PRODUCT CHANGE NOTIFICATION

REVISED:

Bourns® Model CDSOD323-Txxx Series TVS Diode Arrays

Additional Assembly and Test Manufacturing Location

Typical Part Marking

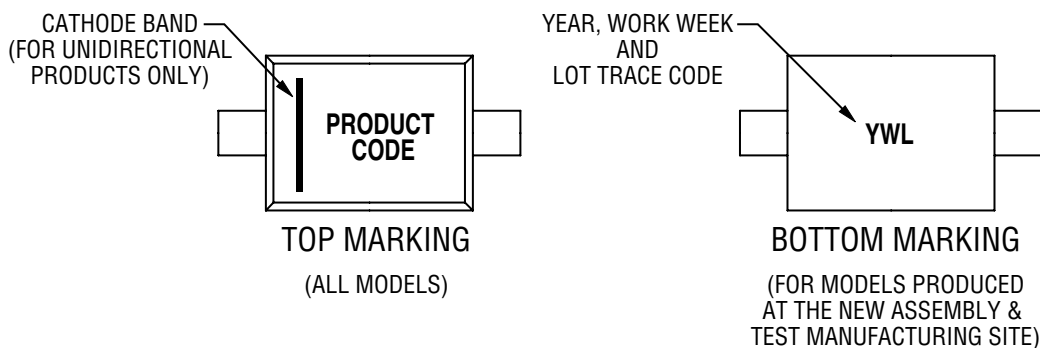
The bottom part marking will be used to identify units produced at the new assembly and test manufacturing site. The bottom marking will include the Year (Y), Work Week (W) and Lot code (L) in alphabetic characters while the current existing site will use only the top part marking.
